Our Ref: SP476931
Your Ref: P/2021/6170
23 August 2021

PLANNING PERMIT APPLICATION: P/2021/6170
ADDRESS: 621 Burwood Highway, KNOXFIELD
PROPOSAL: Utility installation, removal of native vegetation and associated buildings and works

From: [Redacted]
Sent: Friday, 25 February 2022 12:30 PM
To: [Redacted]
Cc: [Redacted]
Subject: FW: Response to RFI2_2021/6170 - 621 Burwood Highway KF - Utility Installation Application
Attachments: DELWP Letter to KCC (Wetland Permit) dated 23 August 2021 (PG response v2.0).pdf; 000318_RPT_DV_Knox Dwarf Galaxias Survey_15022022.pdf; Engeny Response MW Letter to KCC (Wetland Permit) dated 9 June 2021.pdf; Knoxfield Development Stormwater Management Rev 13.pdf

Inundation Frequency

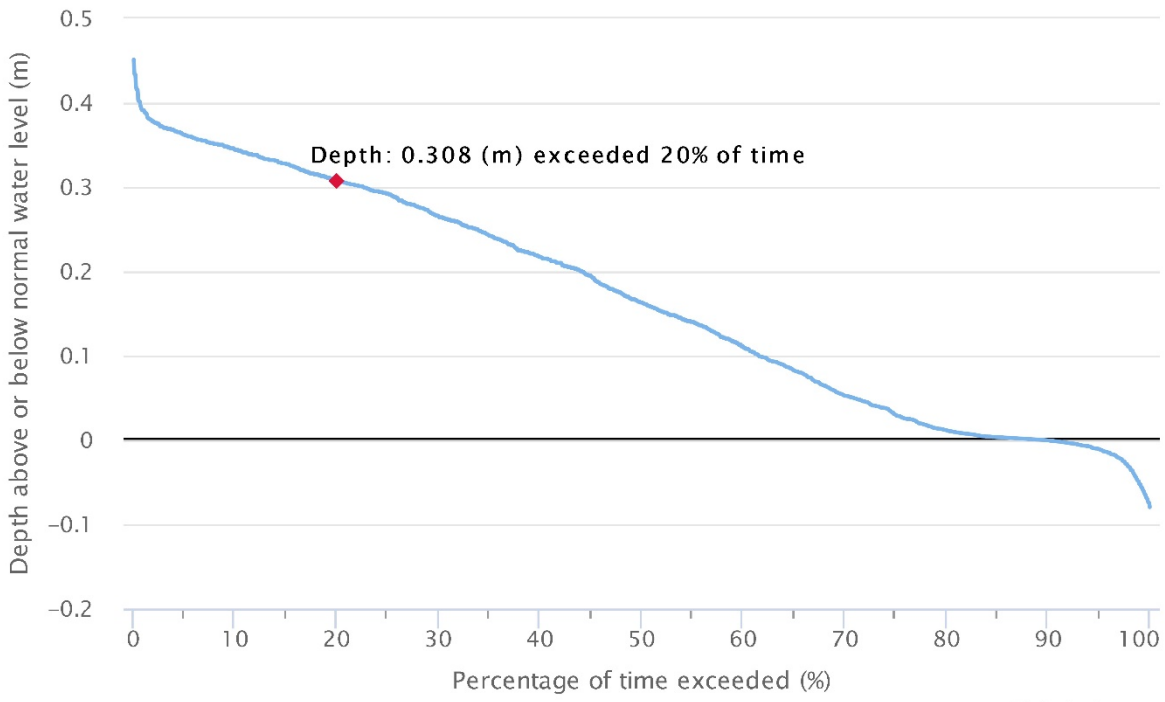
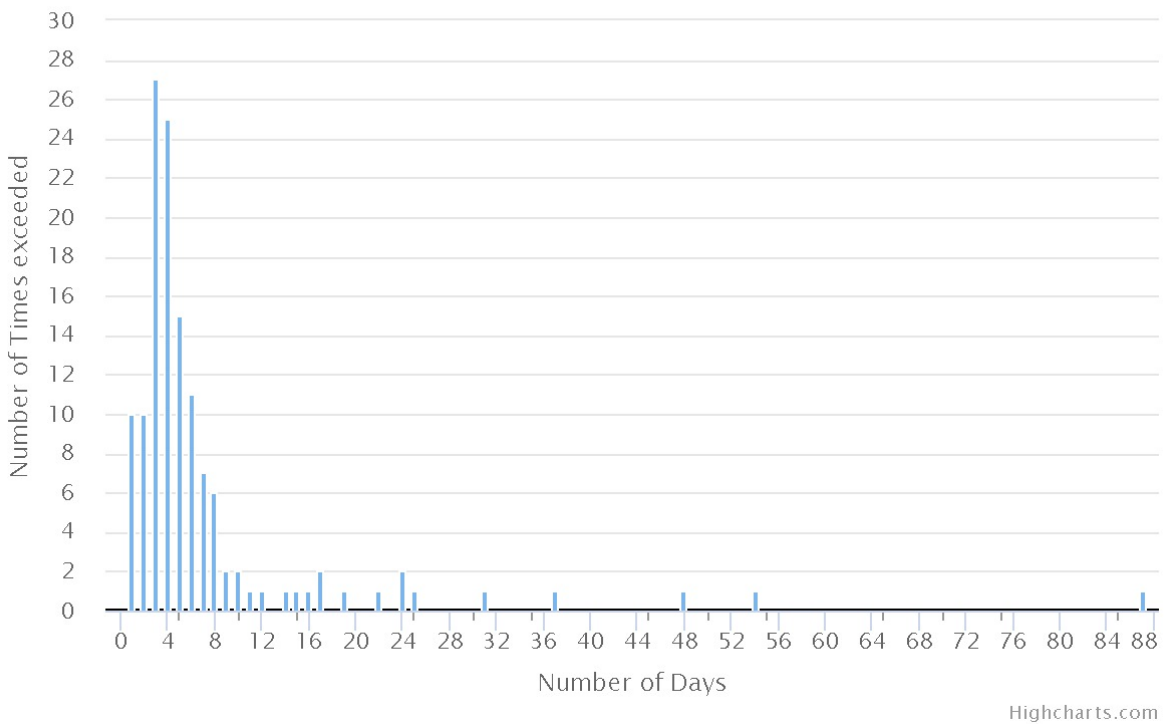
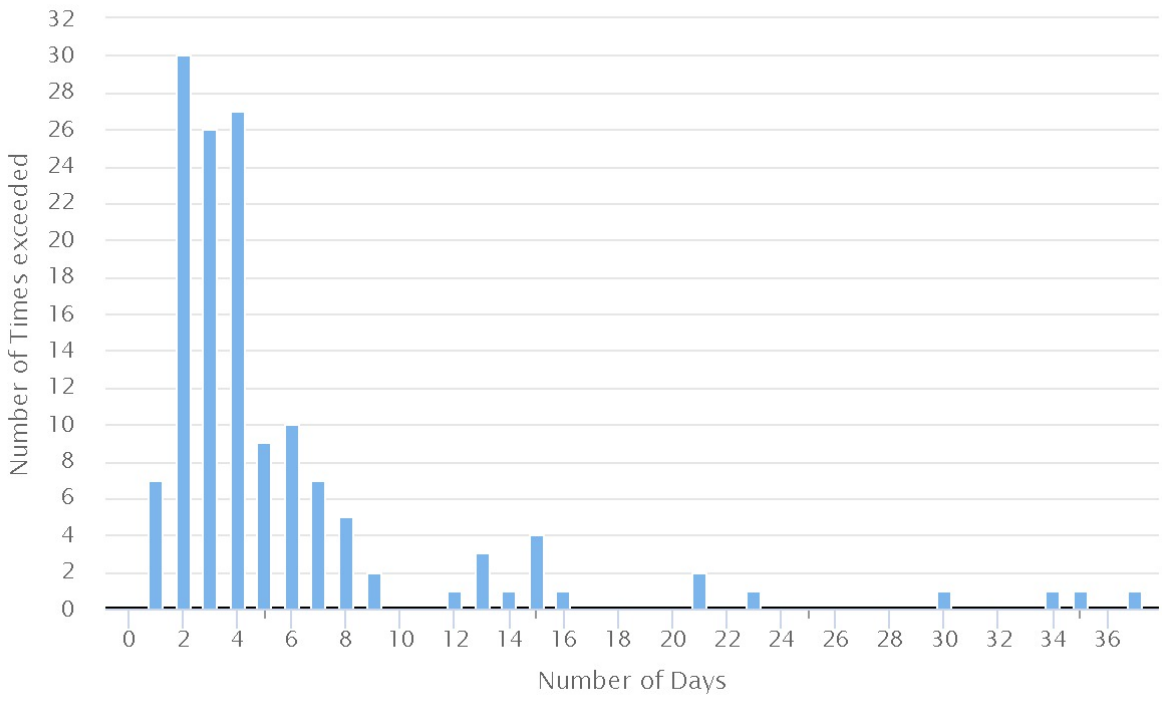
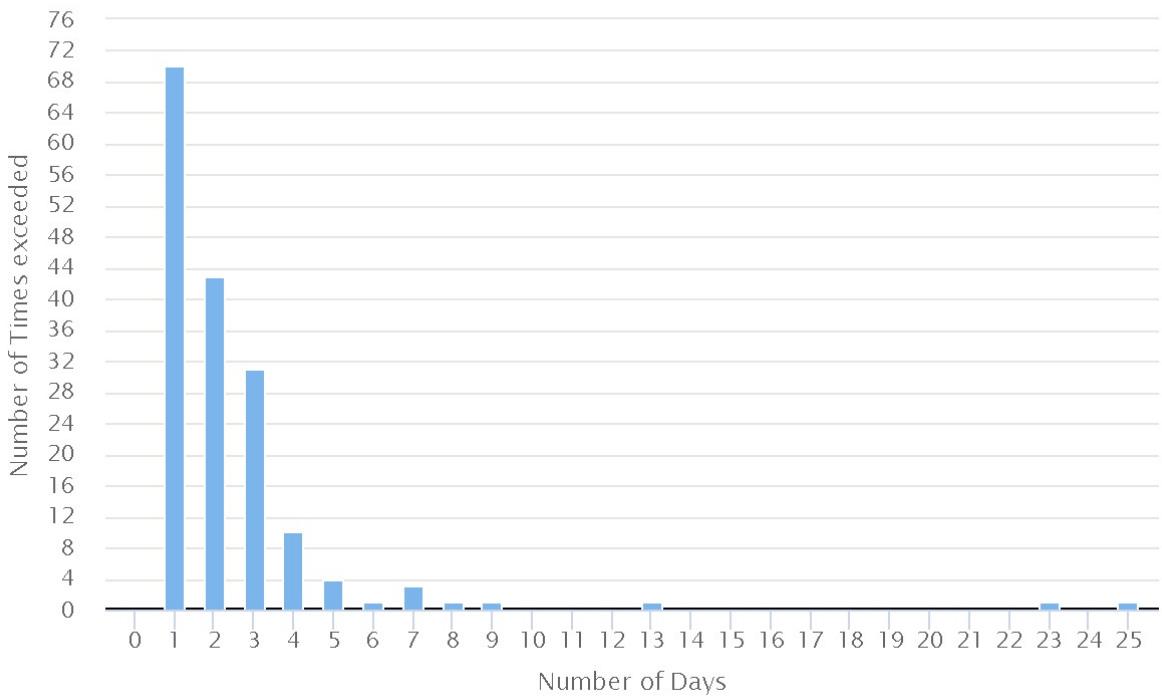
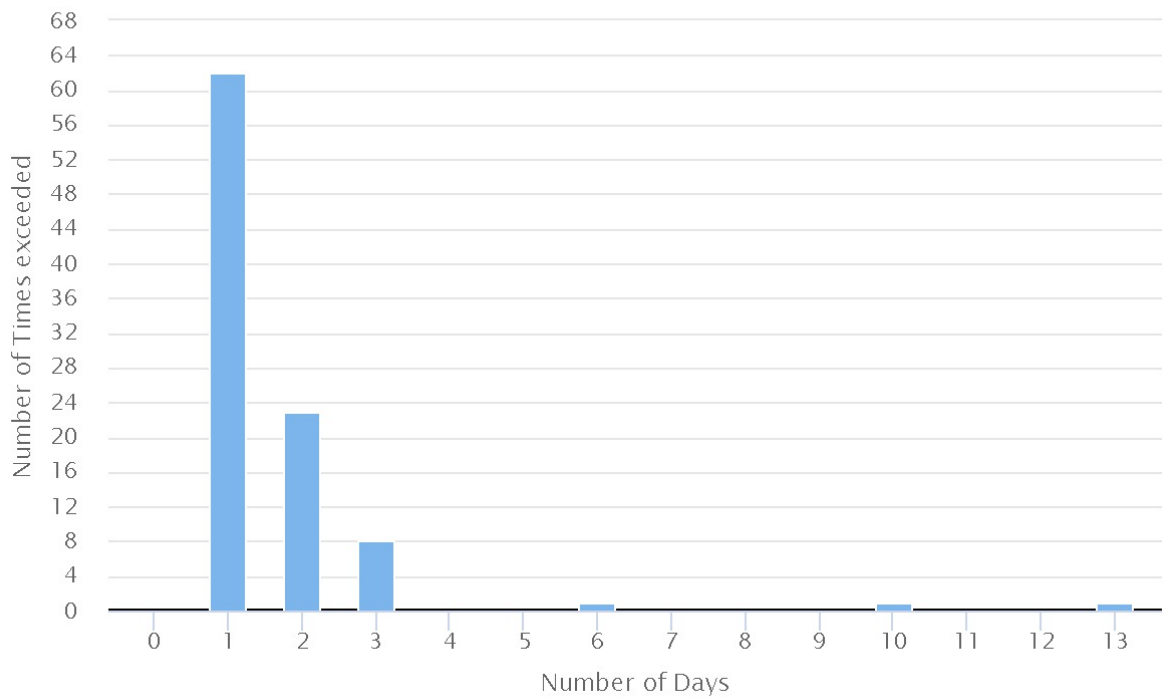
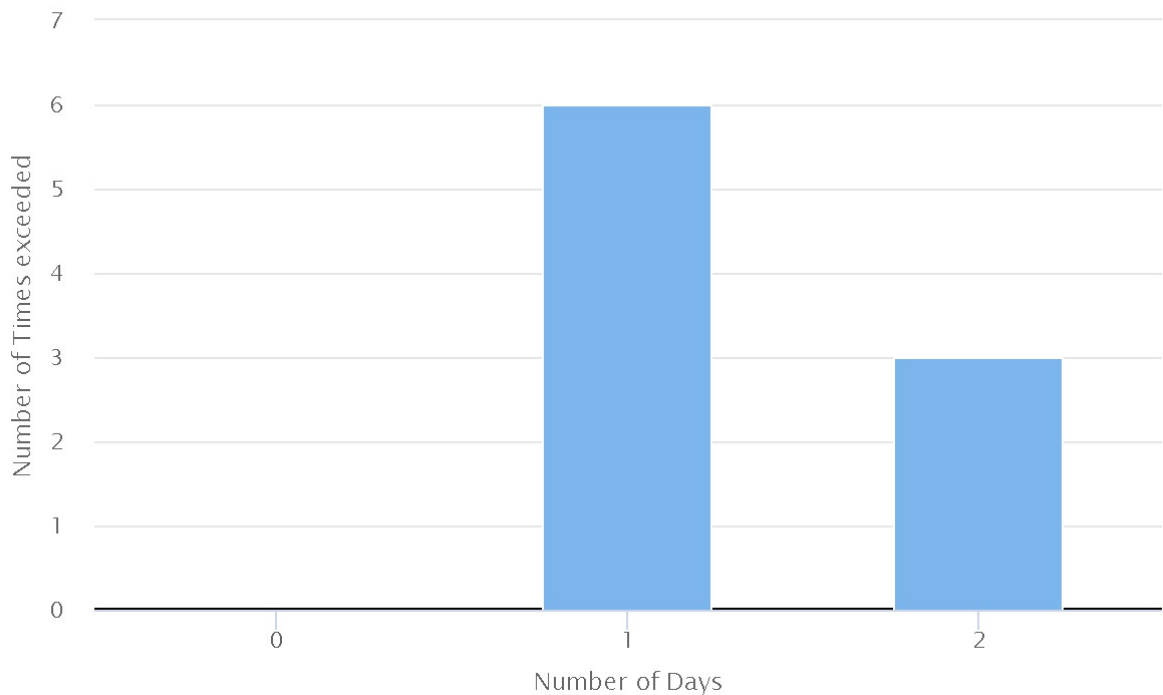
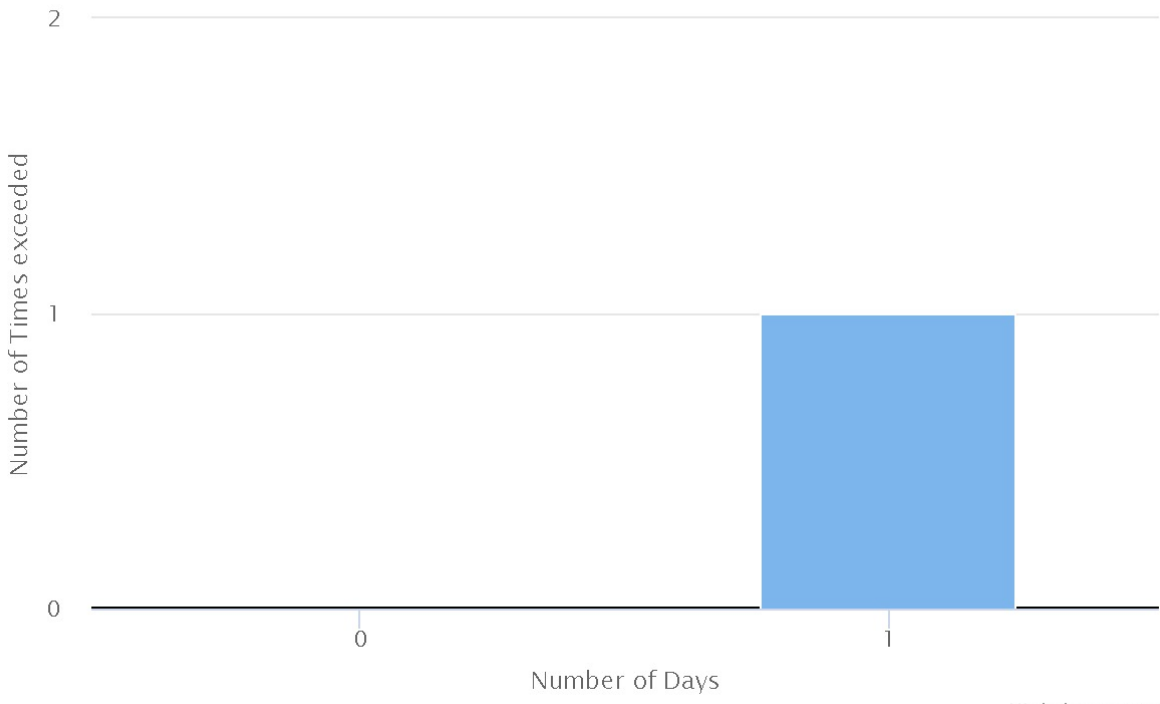
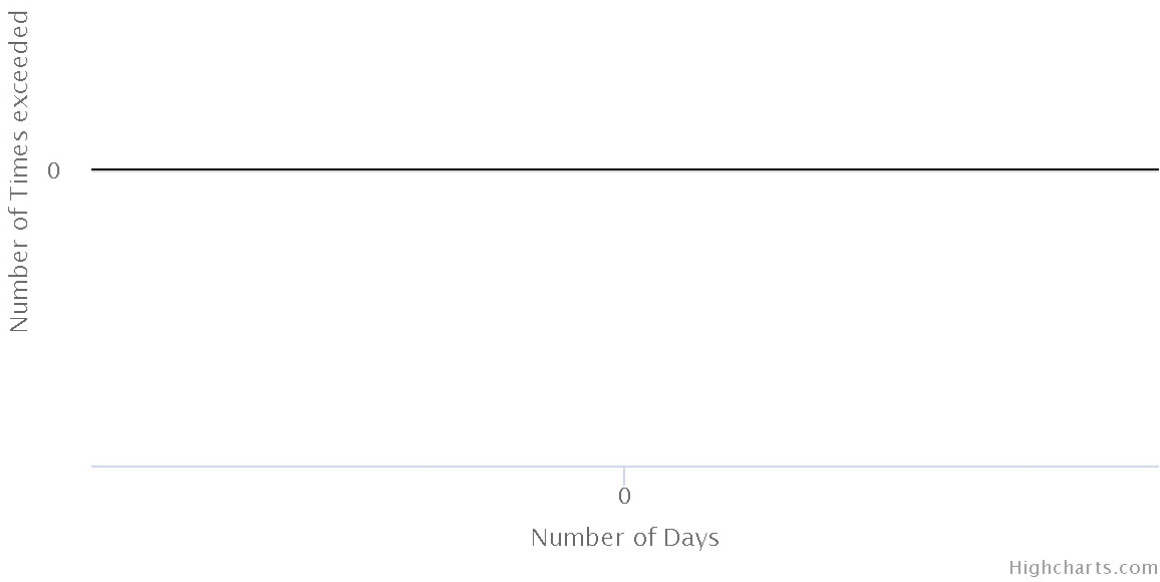
Given the discussion around the proposal of separating the water level control of the stormwater treatment wetland and the habitat wetland, Engeny completed an analysis to show what the impact would be on the stormwater treatment wetland if the water level control was solely within the stormwater treatment wetland.

The results below show the inundation frequency curve and spells analysis for the stormwater treatment wetland acting alone to provide the extended detention control. The figures show that the 300 mm depth is exceeded on approximately 150 different occasions over the 5-year period. This equates to just above 1 a month.

This rate of exceedance would make it highly likely that the water level would extend to 300 mm above the normal water level during the incubation period of the Blue-billed Duck. 350 mm is exceeded on 96 occasions as opposed to this depth not being exceeded once if the wetland functions as a single water body. Given that some of the best habitat (highest reed density) is likely to be within the stormwater treatment wetland, separating the wetlands and having the extended detention flow control contained to the stormwater treatment wetland only increases the risk of nesting within this section of the wetland being impacted quite significantly by higher water levels.

Figure 7-2: Cross section AA

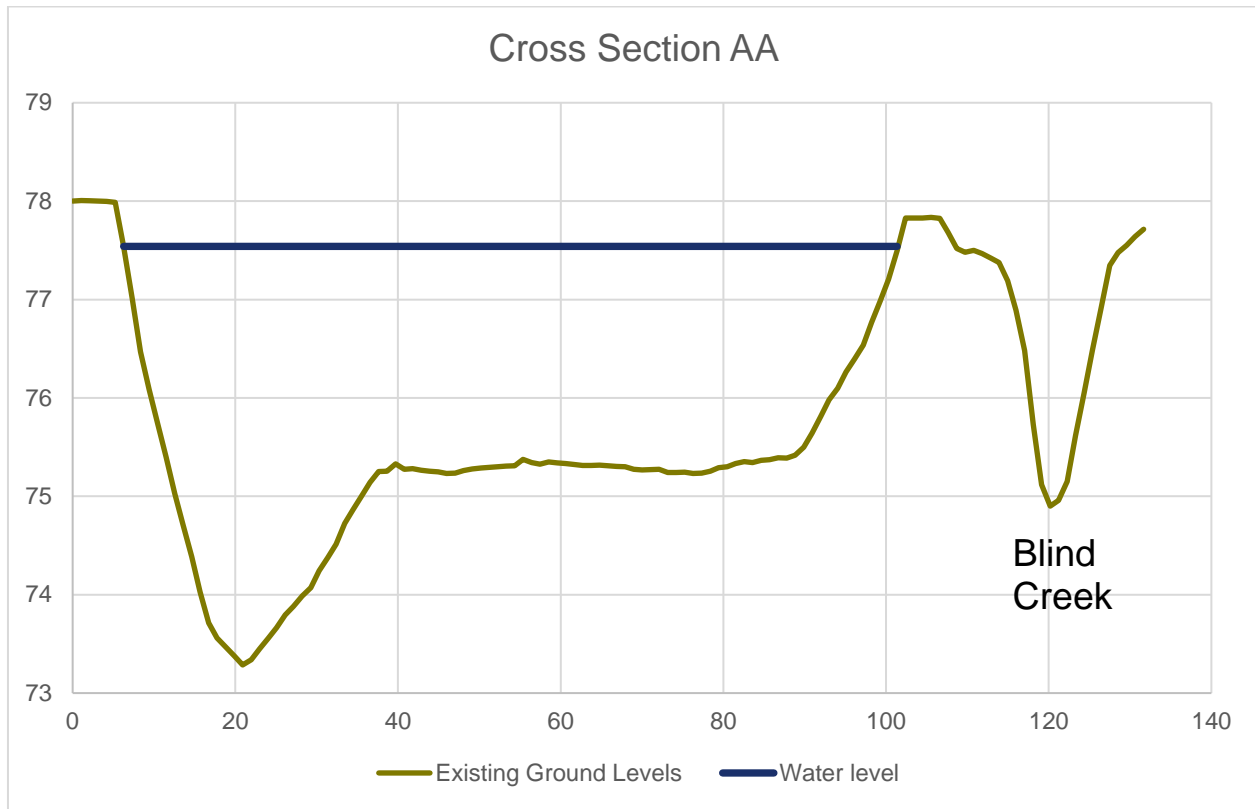
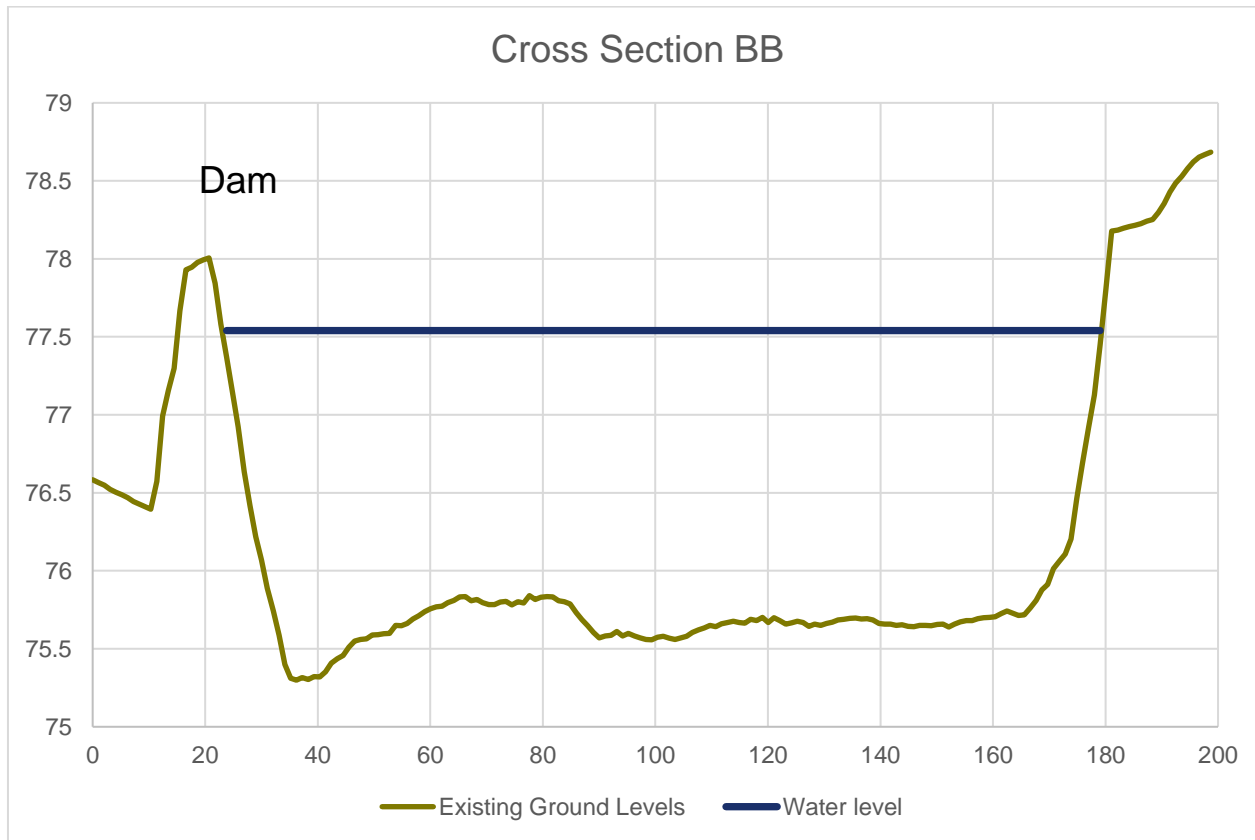
6. Provide a comparison of habitat that the existing water body provides vs the proposed new wetland system. Include slope embankment and depth of water. The newly constructed wetland systems need to incorporate comparable habitat structure, preferred habitat of the Blue Billed Duck (as demonstrated by breeding success on site), is recreated in the manmade wetland system.

Response Knox Biodiversity Team: Please provide source of this information and data provided. Unable to comment further without additional information. The information should also be referred to Melbourne Water for a response.

Figure 7-1 shows the digital elevation model and elevation contours of the existing dam. The levels within the dam are of the floor of the dam and were captured via bathymetric survey. Figure 7-2 and Figure 7-3 show two cross sections through the dam along the lines AA and BB shown in Figure 7-1. The figures show that the average depth of the dam, when full is approximately 1.5 to 2 m. There is a small section in the south west corner of the dam which is up to 4 m deep. This area was likely constructed as a sump in the dam and may have been used as a borrow pit to extract material to construct the dam wall. The previous utility for the dam and its intent when it was constructed (prior to the acquisition of the site by Development Victoria) was to provide irrigation water for the horticultural activities which were a significant use of the site.

The proposed habitat wetland will aim to mimic but improve on the bathymetry of the existing dam. The habitat wetland will feature safe batter slopes of 1 in 8 extending at least 2.4 m from the normal water level into the waterbody. This will also provide for dense fringing reed beds around the edge of the wetland, a habitat feature which is missing from the majority of the existing dam as the banks are quite steep. After the safety bench the habitat wetland will transition to a depth of 1.5 to 2 m at slopes of up to 1 in 3 to maximise the area of deep water. An undulating base is proposed to try and mimic a more naturalised system and avoid a largely flat engineered base. This will mean that the majority of the habitat wetland will remain as open water and will be planted with the same species of plants which currently occur in the base of the dam. If possible, some plants will be relocated from the dam to the habitat wetland.
